WEST SUSSEX COUNTY COUNCIL CONSULTATION

TO:	Arun District Council FAO: Hannah Kersley
FROM:	WSCC – Highway Authority
DATE:	6 October 2026
LOCATION:	Hampton Park Littlehampton
SUBJECT:	LU/252/25/RES Approval of reserve matters following LU/47/11/ (as amended by LU/182/15/) for the remaining open space elements including playing pitches, changing rooms, car parking area, northern allotments and the eastern extent of the Black Ditch Open Space. Substitute and Supplementary drawing pack plans received.
DATE OF SITE VISIT:	n/a (desktop study undertaken for purposes of this planning application)
RECOMMENDATION:	More Information Required

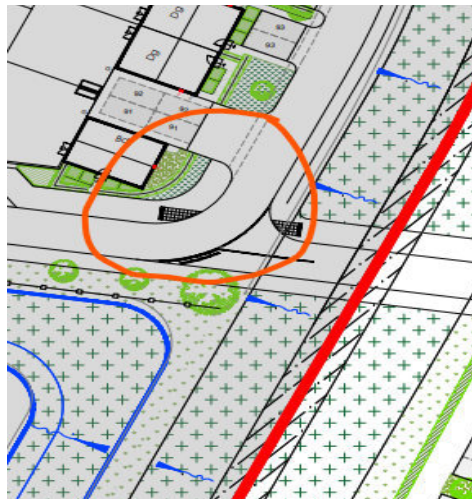
- A plan showing provision for a coaches (plus swept path analysis of the same).
- A plan showing EV parking provision.
- A plan showing secure, covered and overlooked cycle parking for a selection of different types of bicycles following guidance in LTN 1/20.
- Applicant to confirm and show that the circulatory path (shown on the plan below/overleaf with the blue line and arrows) is to run alongside parking spaces for continuity and that where it crosses the access road and parking area that it will be provided with dropped kerbs and tactile paving. Visibility splays for users should also be shown. With regard to the design, it would be better seeing the path run around the southern end of the car park to avoid users having to cross the car park. Applicant to consider this.

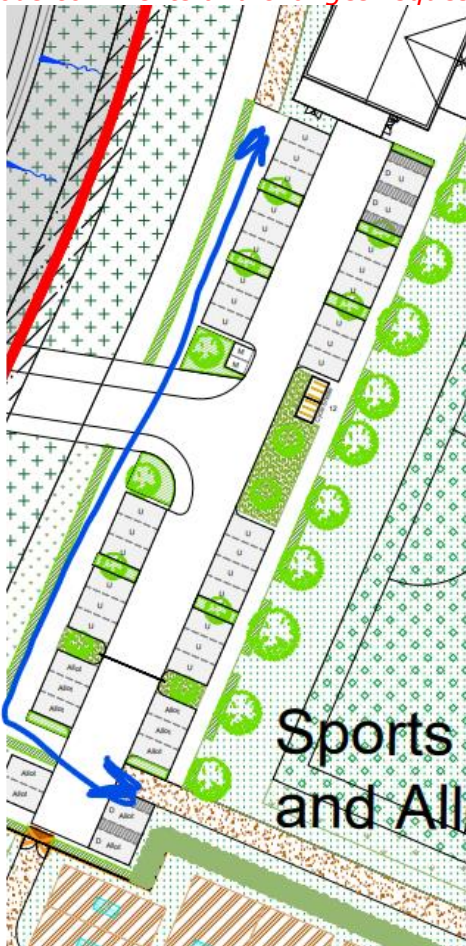
- A plan showing provision for a coach (plus swept path analysis of the same).
This is now shown on Drawing PHLITTLEOS.2/TK02 Rev 'P1' – 'SWEPT PATH ANALYSIS COACHES IN PAVILION AREA' and also shows the swept path diagrams for a light van.

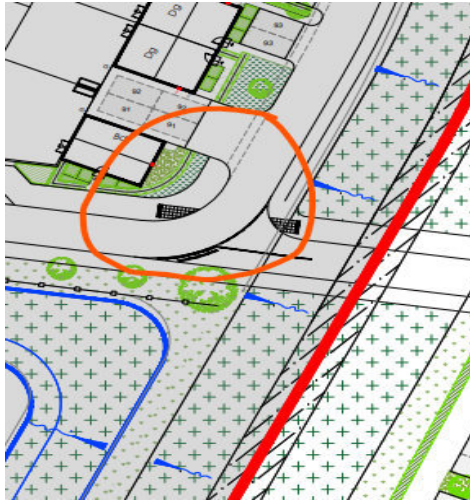
- Applicant to confirm and show that the circulatory path (shown on the plan below/overleaf with the blue line and arrows) is to run alongside parking spaces for continuity and that where it crosses the access road and parking area that it will be provided with dropped kerbs and tactile paving. Visibility splays for users should also be shown. With regard to the design, it would be better seeing the path run around the southern end of the car park to avoid users having to cross the car park. Applicant to consider this. *The 'Surface Treatments' plan (PHLITTLEOS.2/131 Rev 'P2') shows the path where the blue line overleaf was shown, removed, with a path now shown to the east of the parking area. Therefore, the previous comments and changes requested now fall away.*

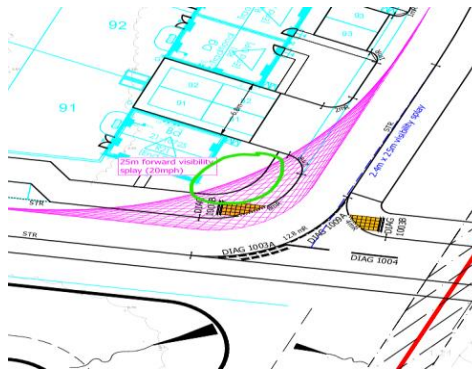
- A plan should also be provided showing forward visibility across this bend (please see overleaf):

This is now shown on General Arrangement Drawing PHLITTLEOS.2/101 Rev'P2' and is based on an access road with a 20mph speed limit, which the applicant promotes for many of the internal access roads within the development. It is, however, observed that part of the splay crosses land that might be in, or become, the curtilage of the building plot on the corner (see the area circled in green on the plan extract below). The applicant should ensure that it is either outside of the curtilage or, if it does cross it, that it is kept clear of any obstruction over 0.6m high in perpetuity.
